REPLACEMENT OF MYNY SEAT LOCKS ON ALL NO. 5, 12, 16, HY-5, AND HY-5-II BIG ELI WHEELS

HY-5 BULLETIN

SUBJECT: REPLACEMENT FOR HANDYMAN JACK

Subject: Bolt Wear in HY-5 Spoke Stack Tenon Chain

Figure 3

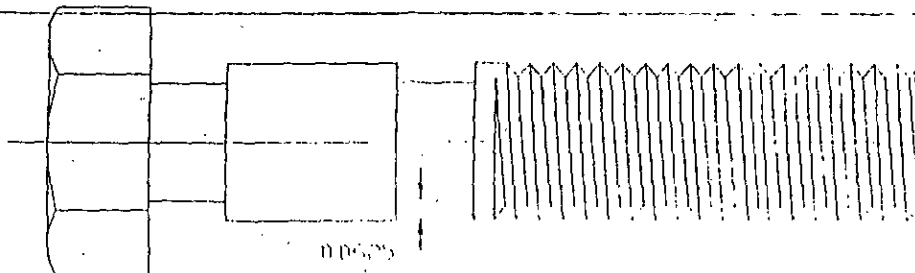
With the nut loosened, move the washer away from the spoke connection plate enough so that the bolt, indicated in Figure 2, can be seen where the inside spoke connection plate bears against it. A worn bolt will have a smaller diameter where the spoke connection plate makes contact with it. The original equipment bolt is $.500''$ ($1/2''$) in diameter. If you can see that any part of the bolt is worn by as much as $.0625''$ ($1/16''$) as shown in Figure 3, the bolt must be replaced.

If the bolt holes in the spoke connection plates or the spoke tenon have elongated from $.0625''$ ($1/16''$) to $.125''$ ($1/8''$) to a total hole length of between $.5625''$ ($9/16''$) and $.625''$ ($5/8''$), then the spoke connection plates and the spoke tenon should be aligned as closely as possible and then reamed to a diameter of $.625''$ ($5/8''$). Then install a $.625''$ ($5/8''$) bolt.

If the bolt holes in the spoke connection plates or the spoke tenon have elongated from $.125''$ ($1/8''$) to $.250''$ ($1/4''$) to a total hole length of between $.625''$ ($5/8''$) and $.750''$ ($3/4''$), then the spoke connection plates and the spoke tenon should be aligned as closely as possible and then reamed out to a $.750''$ ($3/4''$) diameter. Then install a $.750''$ ($3/4''$) bolt.
